DART SERVICE INSTRUCTION

TO AMEND INSTALLATION INSTRUCTIONS D205-523 REV. F, AND INSTRUCTIONS FOR CONTINUED AIRWORTHINESS ICA-D205-523 REV. 1 OR LATER APPROVED REVISIONS

FIGURE 1: Relocation of the D2224 Rappel Anchor
LH Installation Shown, RH Installation Opposite

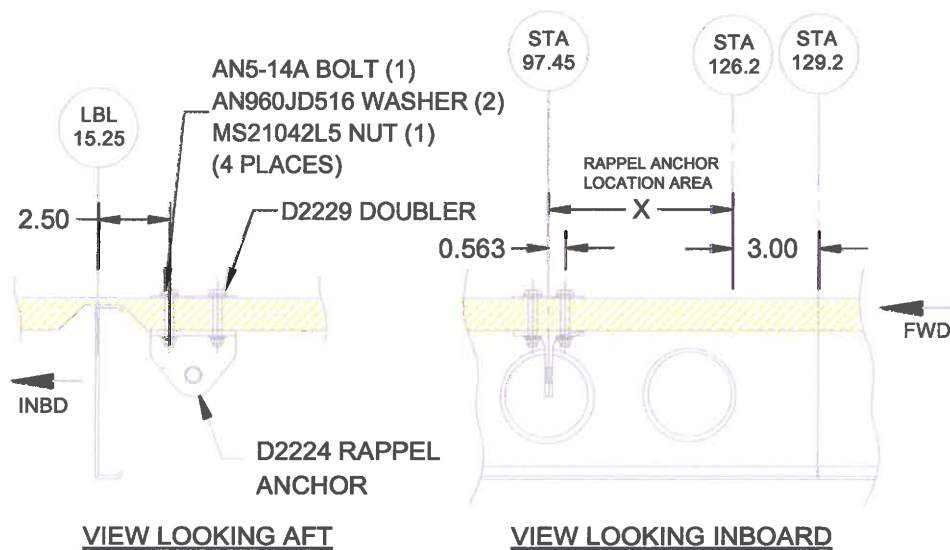
Installation of the D2224 Rappel Anchor per Figure 4 of D205-523 Rev. F may not be compatible with some components on later S/N aircraft. This DSI provides an alternate position for the installation of the D2224 Rappel Anchor.

2.1.1 It is acceptable to install the D2224 Anchor Assembly between STA 97.45 and STA 126.2, as shown in Figure 1 of this DSI instead of the location shown in Figure 4 of D205-523 Rev. F. Keep the innermost attachment hole 2.50" from LBL/RBL 15.25 as outlined in Figure 1 of this DSI. The D2224 Anchor Assembly, D2229 Doublers, and associated hardware are otherwise installed i.a.w. Section 3 of Installation Instructions D205-523.
